**7350322
Repair Fuel System
B4505**

**MCAS Cherry Point, NC
AMENDMENT #0001**

Project Number 7350322, Repair Fuel System B4505, Marine Corps Air Station Cherry Point, NC

A. This amendment provides responses to pre-proposal inquiries:

1. 12858688 SITE PLAN

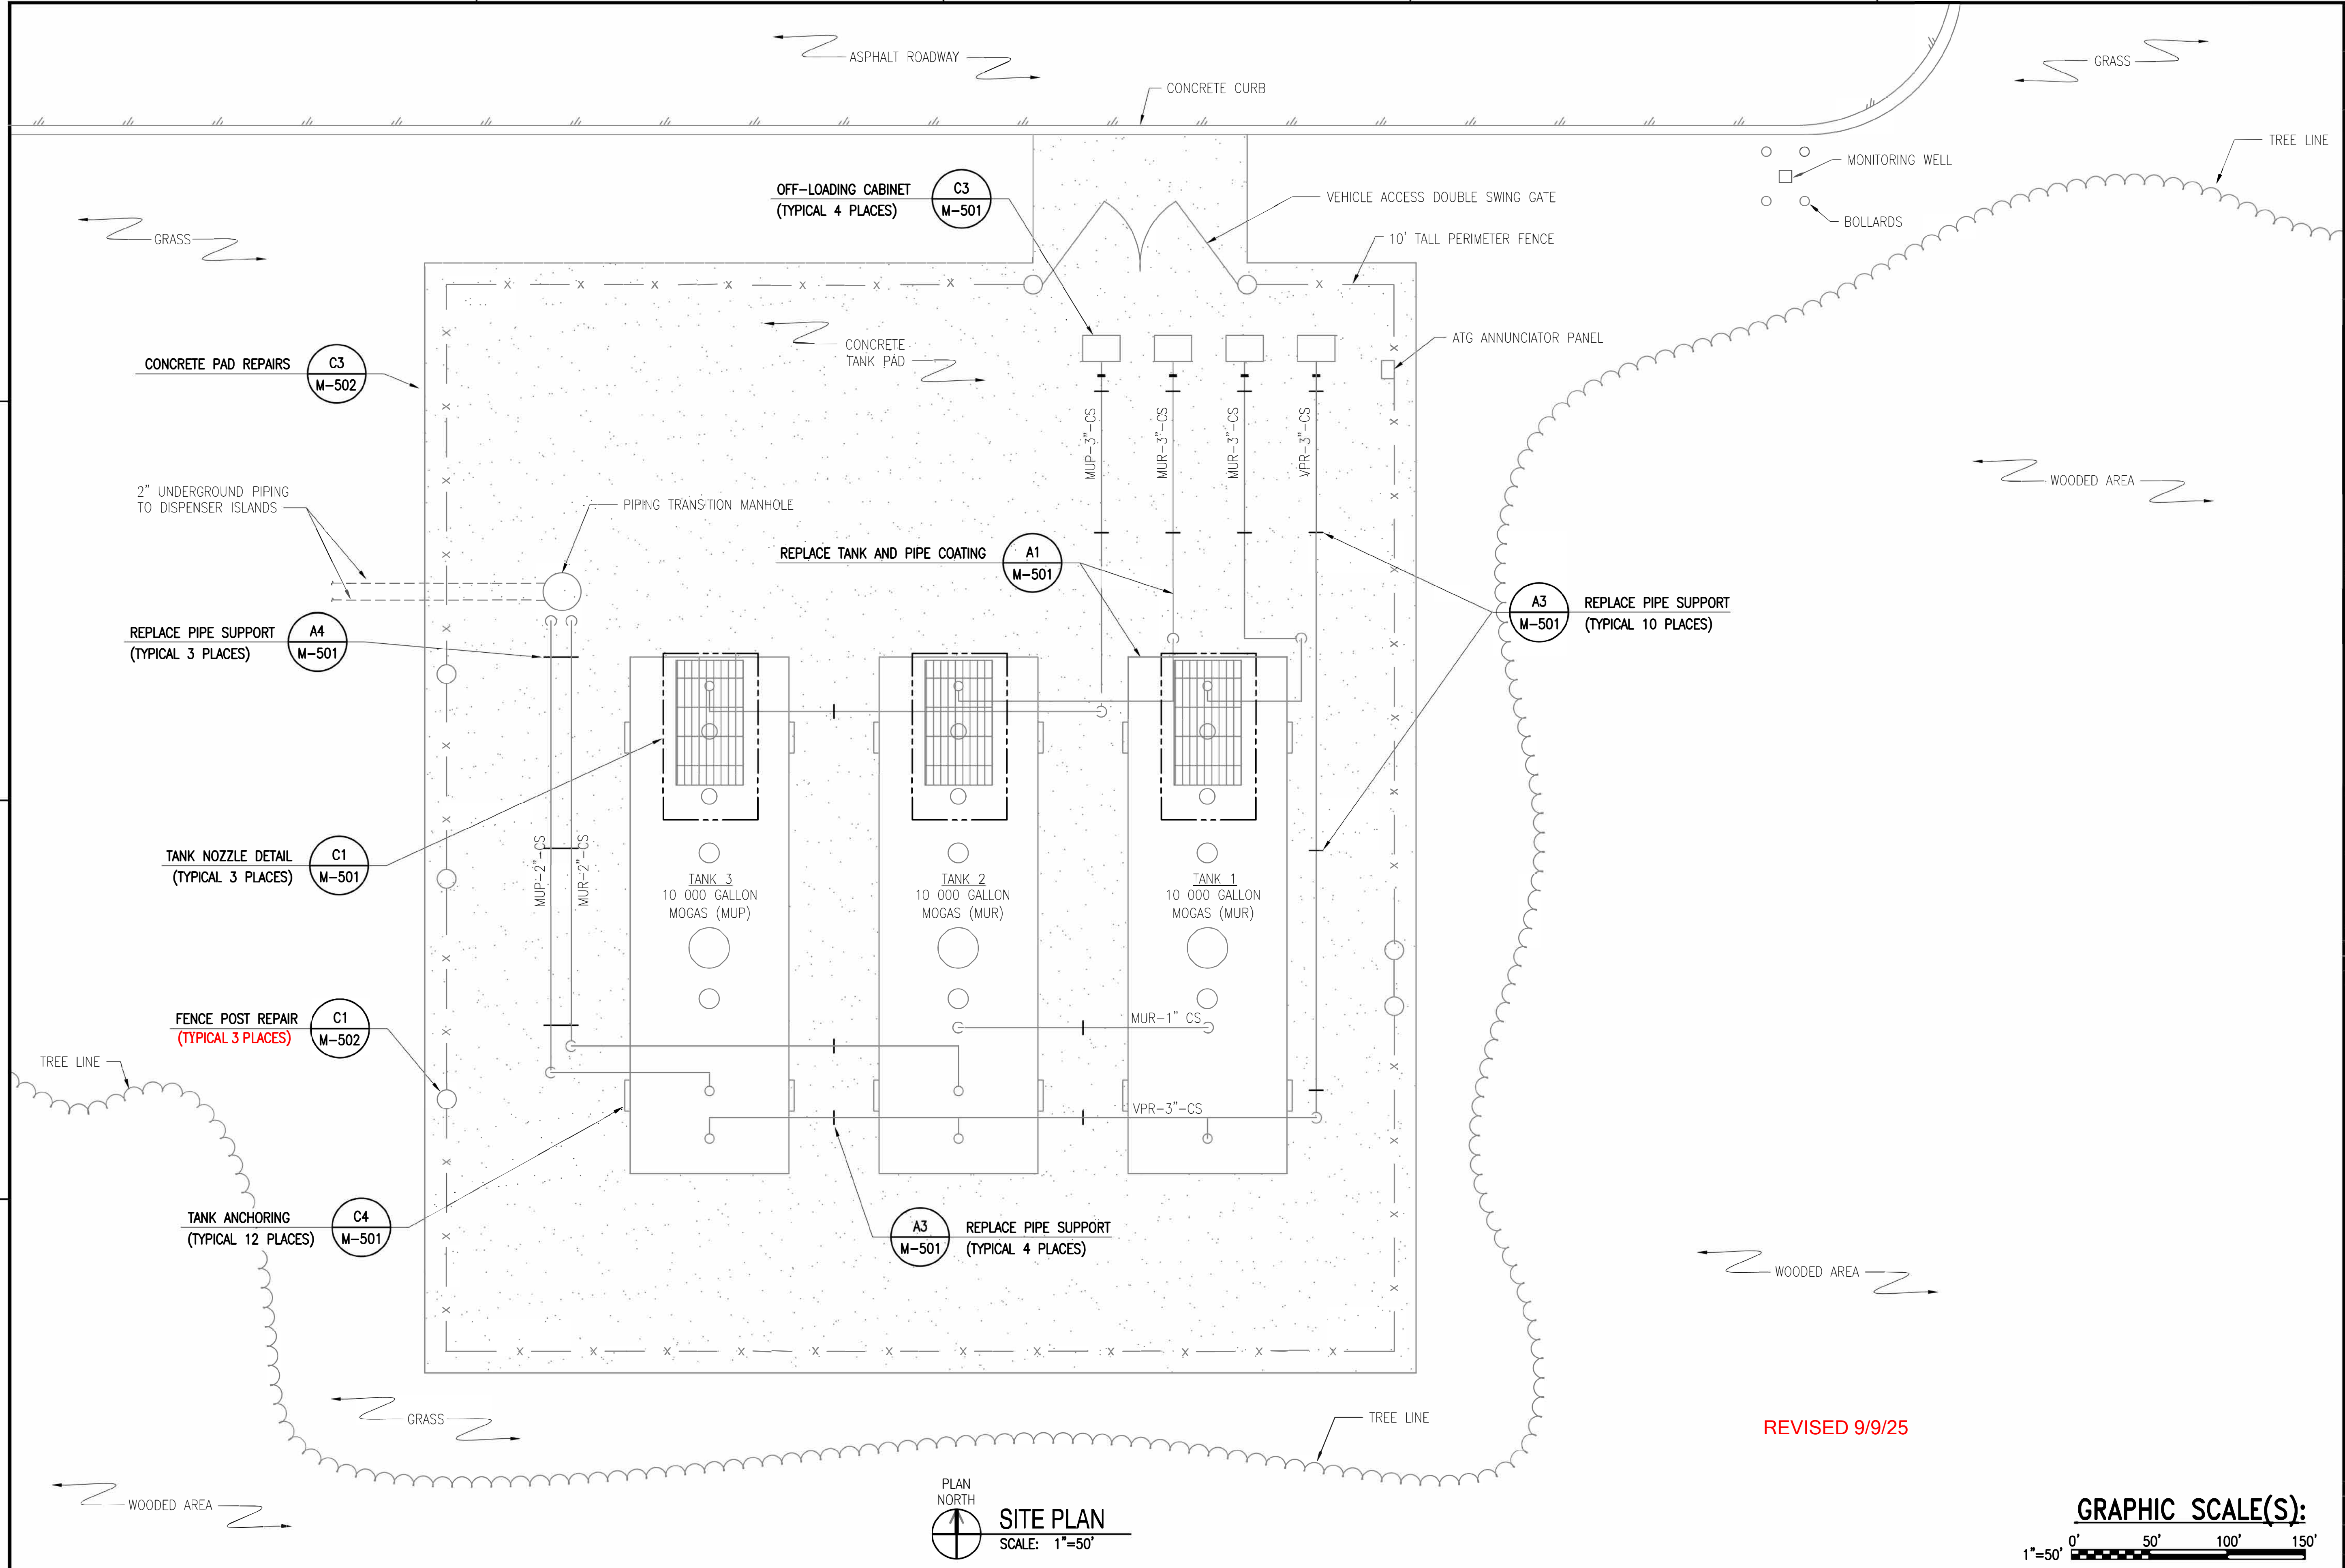
2. Drawing M-101 indicates for the contractor to remove and replace Tank 1 which has a stated fuel capacity of 10,000 Gallons. However, Spec Section 33 57 55 (FUEL SYSTEM COMPONENTS (NON-HYDRANT)) only indicates the acceptable materials for the new tank and the type of fuel that the new tank can hold. Can Spec Section 33 57 55 be revised by Amendment indicating the additional salient characteristics of the new tank required for the project?

3. After visiting the project site and reviewing the project drawings with the on-site MCCS General Manager, the Building Tenants are under the impression that all (3) Fuel Tanks are to be replaced as part of this project. However, the project drawing details require the contractor to replace Tank 001 only. Will Tanks 2 & 3 be added to the project by Amendment, Post-Award Modification or be completed as part of a future MACC RFP(s)?

5. Drawing M-101 indicates for the contractor to repair (1) Fence Post on the west side of the existing fence that encloses the existing fuel tanks. However, after visiting the project site, all of the existing fence posts on the west side of the fence are damaged and will require repair. Can it be confirmed by Amendment that all of the existing fence posts on the west side of the fence are to be repaired by the contractor?

No tanks are being replaced. The scope of work is to replace tank and pipe coatings for all 3 tanks. Reference Specification Section 01 11 00 Paragraph 1.1.1. Submit proposals in accordance with RFP, Specifications, Drawings and all amendments.

No tanks are being replaced. The scope of work is to replace tank and pipe coatings for all 3 tanks. Reference Specification Section 01 11 00 Paragraph 1.1.1. Submit proposals in accordance with RFP, Specifications, Drawings and all amendments.

Reference NAVFAC Drawing 12858690 Detail C1 stating New Fence Post (Typical of 3). Reference revise NAVFAC Drawing 12858688 Site Plan Detail C1 stating Fence Post Repair (Typical 3 Places). Submit proposals in accordance with RFP, Specifications, Drawings and all amendments.
